**STATE OF RHODE ISLAND AND PROVIDENCE PLANTATIONS**  
Rhode Island Atomic Energy Commission  
16 Reactor Road  
Narragansett, RI 02882-1165  
Telephone # 401-874-2600

Subject: Response to Request for Additional Information Dated December 26, 2019, Re: Part 71 Quality Assurance Program

**Rhode Island Nuclear Science Center**

**Revision 7 DRAFT**

Figure 1: RINSC Organization Chart

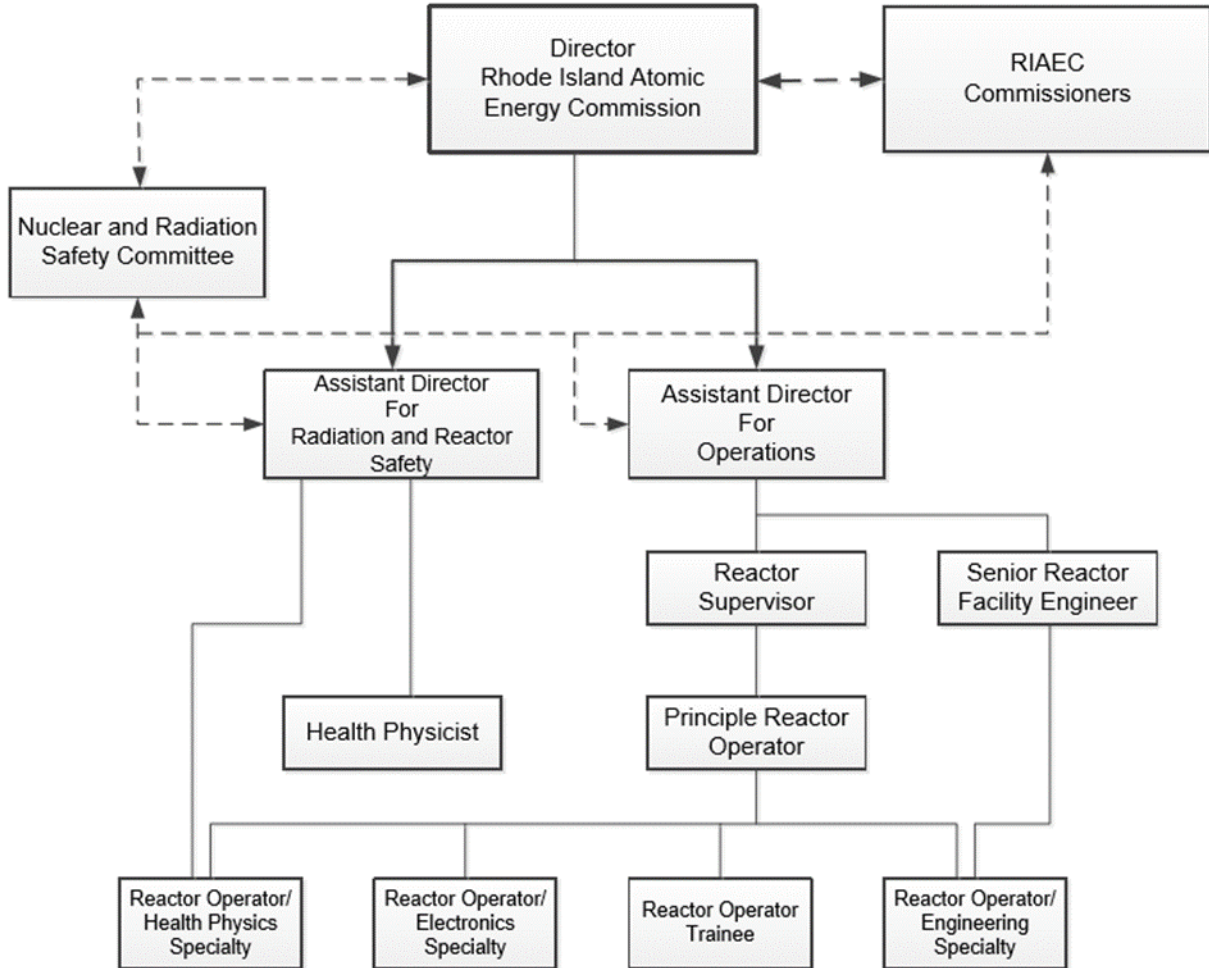
1. Provide a description of how the current organization provides assurance that the required authority and organizational freedom, including sufficient independence from cost and schedule, when opposed to safety considerations, are provided.

All Reactor Operations and Health Physics personnel may perform functions under this QA program as designated by the Facility Director or Assistant Directors. Individuals performing QA functions have the responsibility and authority to stop unsatisfactory work or use of nonconforming materials and have direct access to the Assistant Directors or Director to ensure the accomplishment of quality-related activities. Personnel performing functions under the QA program must also report unsatisfactory work or use of nonconforming materials to the Nuclear and Radiation Safety Committee (NRSC), which acts as an oversight body, independent from the Reactor Operations group.
